**From:** [S Mason](#)  
**To:** [Rebecca Noecker](#)  
**Cc:** [Spencer Miller-Johnson](#); [\\*CI-StPaul Contact-Council](#)  
**Subject:** Public Comment in Opposition to Proposed EGAOD changes. Add a rear setback and step back to the EGAOD.  
**Date:** Friday, July 19, 2024 1:06:09 PM  
**Attachments:** [1- ANNOTATED Parritz public comment presentation.pdf](#)  
[2-ANNOTATED Parritz public comment presentation.pdf](#)  
[3-ANNOTATED Parritz public comment presentation.pdf](#)  
[4-comments.pdf](#)  
[5-Comments.pdf](#)

**ANNOTATIONS TO PUBLIC COMMENT IMAGES**

Here is an image of 695 Grand as built, with December Shadows.

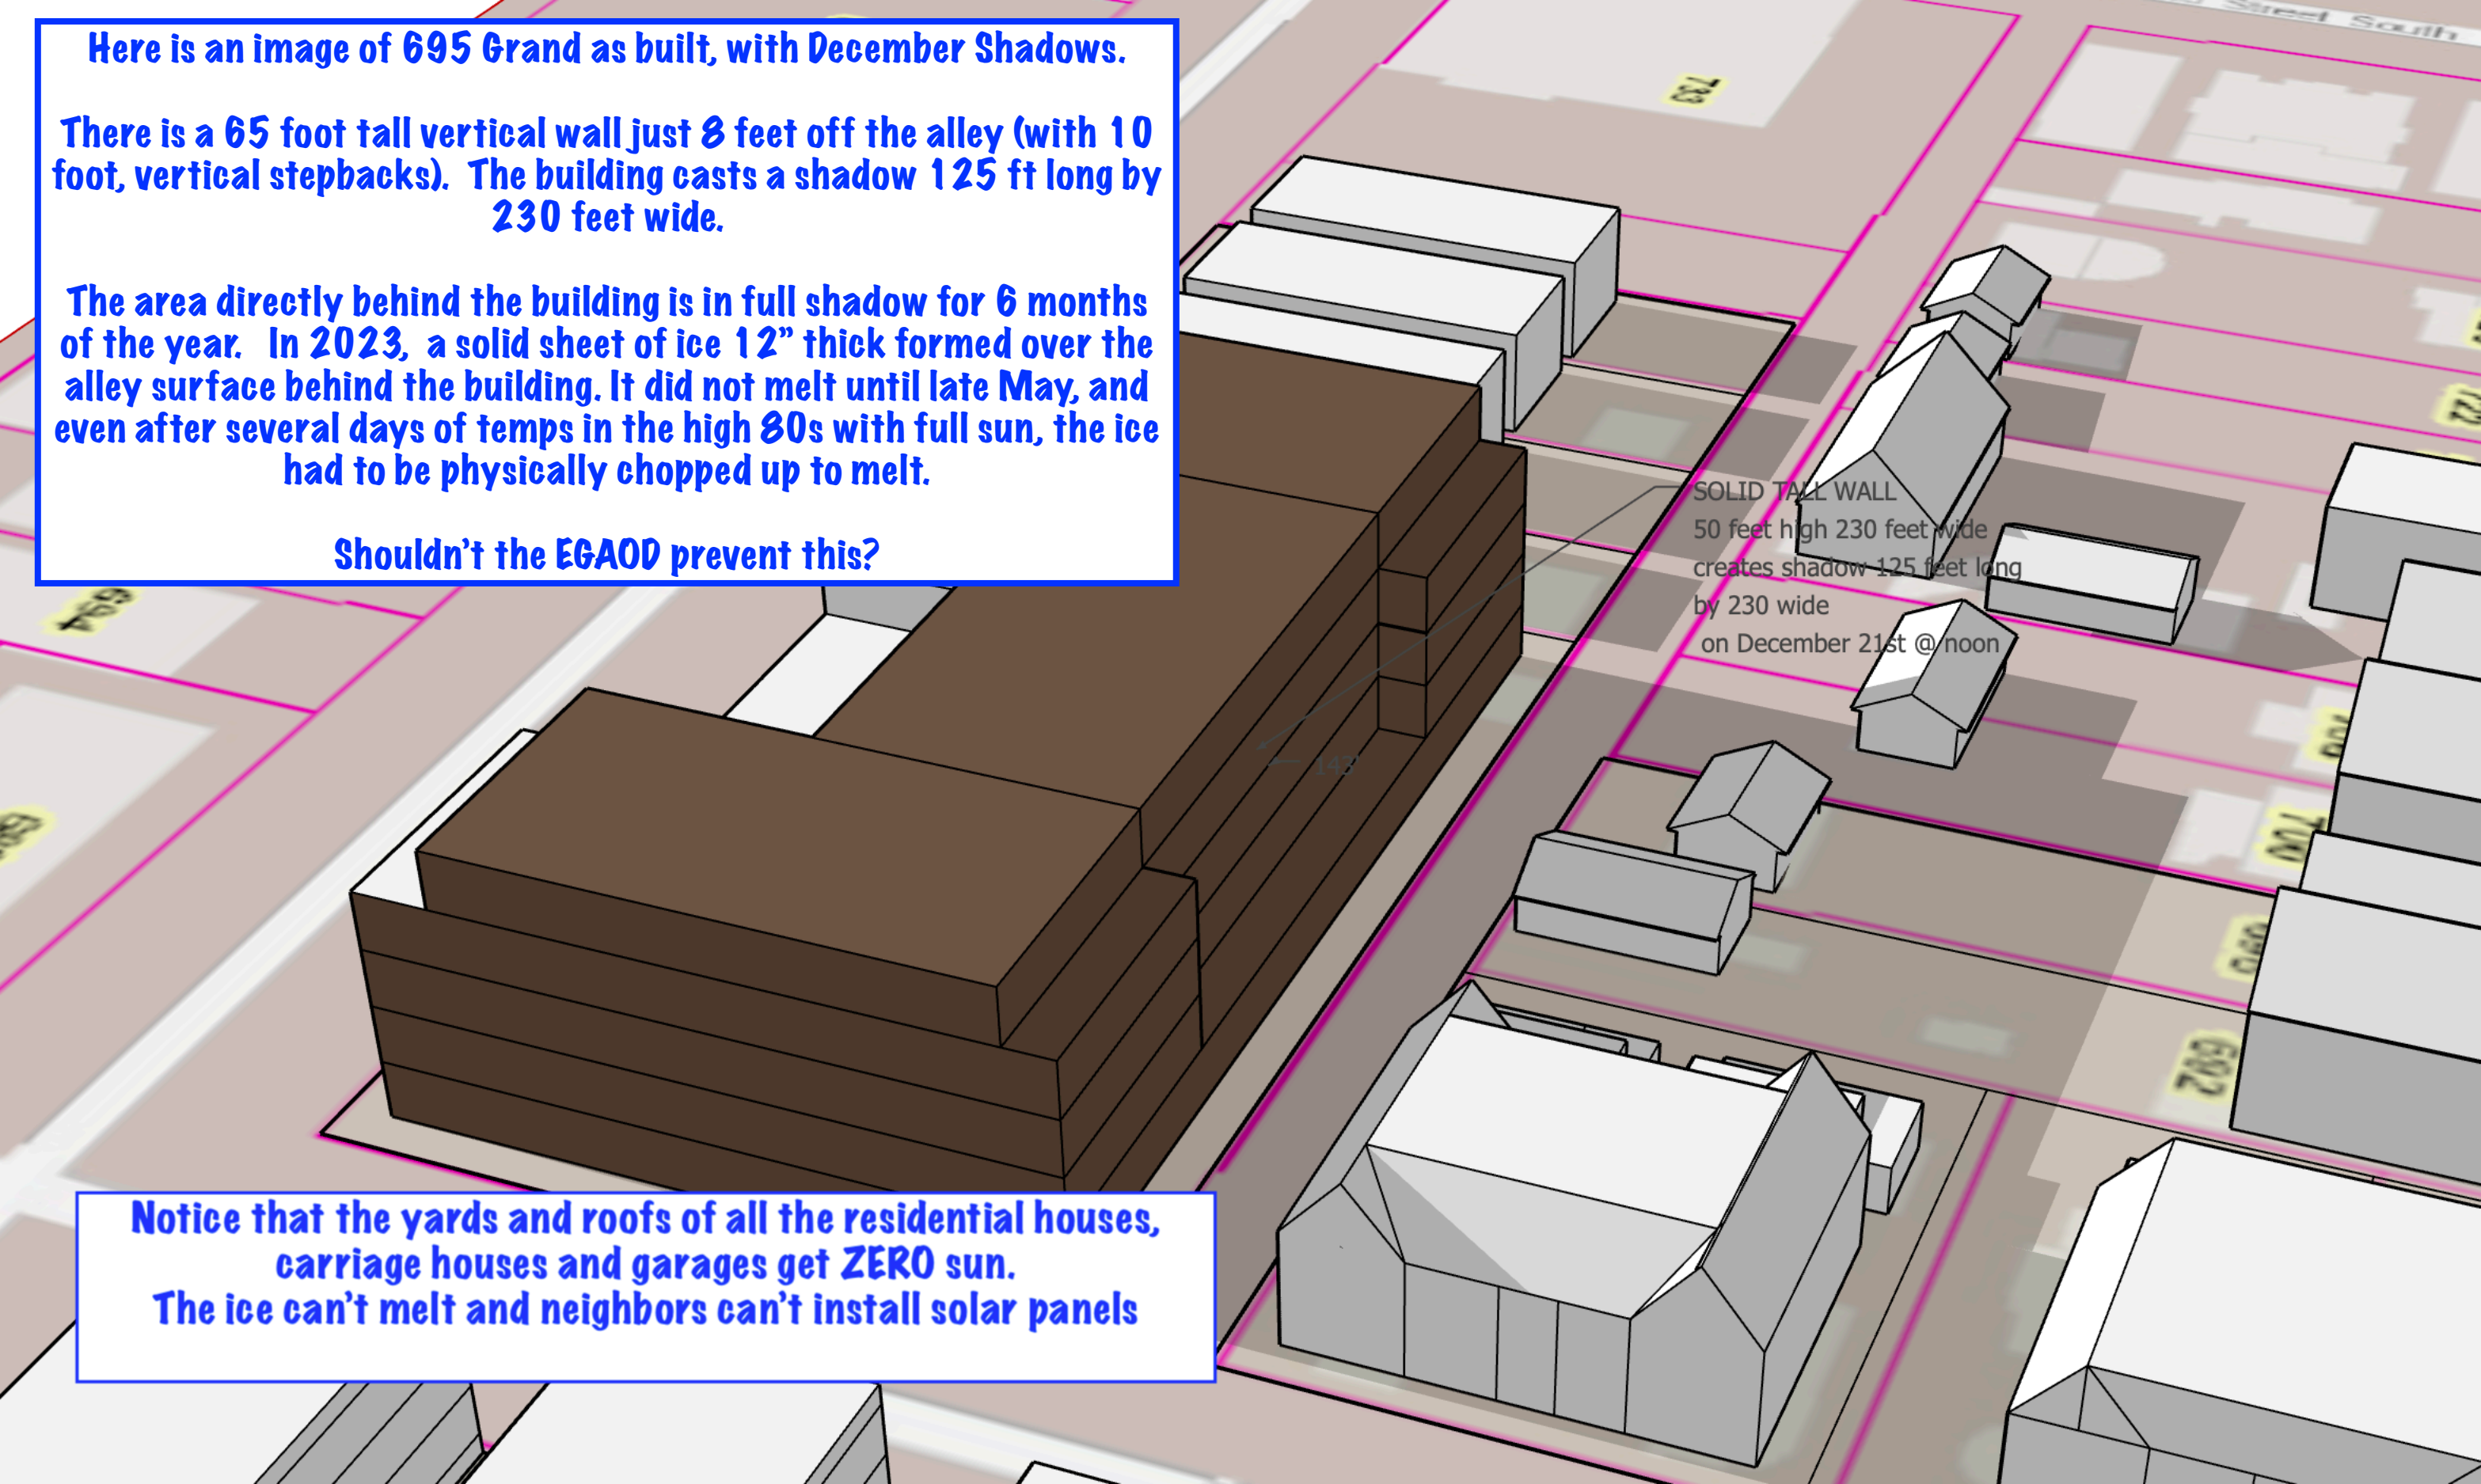
There is a 65 foot tall vertical wall just 8 feet off the alley (with 10 foot, vertical stepbacks). The building casts a shadow 125 ft long by 230 feet wide.

The area directly behind the building is in full shadow for 6 months of the year. In 2023, a solid sheet of ice 12" thick formed over the alley surface behind the building. It did not melt until late May, and even after several days of temps in the high 80s with full sun, the ice had to be physically chopped up to melt.

Shouldn't the EGAOD prevent this?

SOLID TALL WALL  
50 feet high 230 feet wide  
creates shadow 125 feet long  
by 230 wide  
on December 21st @ noon

Notice that the yards and roofs of all the residential houses, carriage houses and garages get ZERO sun.  
The ice can't melt and neighbors can't install solar panels
